### LAVALLEE BRENSINGER ARCHITECTS

### Field Report

Ticia neport							
The Park Danforth			Project No:		13-059-00		
Portland	ME		Field Report N	o:	20		
To:	Mark Donovan		Time of Visit:	8:00	AM		
	PC Construction		Date of Visit:	10/1	1/2016		
	131 Presumpscot Street		Weather:	Sunr	ny, Cool 45F		
	Portland	ME					
Submitted by:	Kim McCarthy		Copies:				
Present:	Scott Timmons (LBA), Kim		Andrew Pires	Р	C Construction

Corridor 1001, See note 20.06

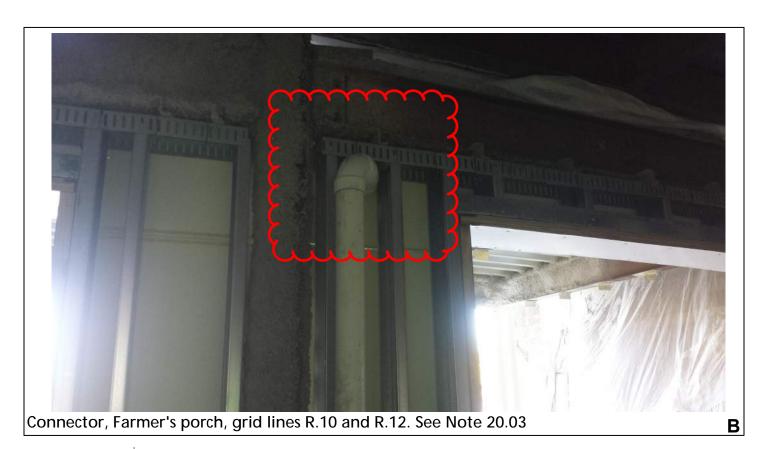
20.06	Add pilasters in corridor 1001 between the Administration Suite and Unit 1103. Coordinate with GWB soffit. See image A P18 of 19 and reference drawing A1.1C	Correct Work

GWB Base at floor slab. See Note 20.08

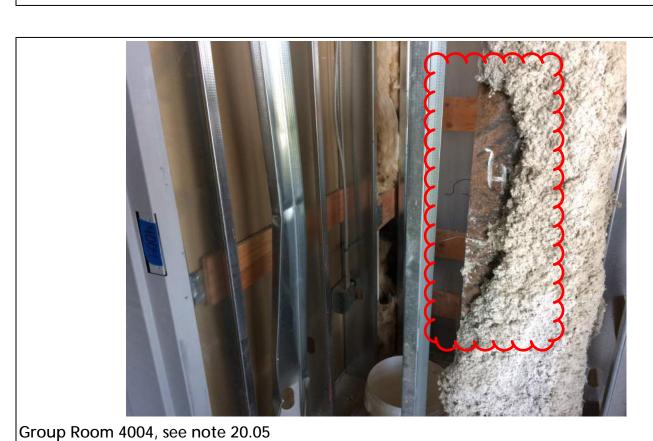
20.07	Verify plastic sheeting in all openings to exterior are sealed to protect interior from water infiltration. See image B P18 of	CM follow up
20.08	Ensure smooth surface at base of wall for vinyl base/verify wall abnormalities will not telegraph through.	CM follow up
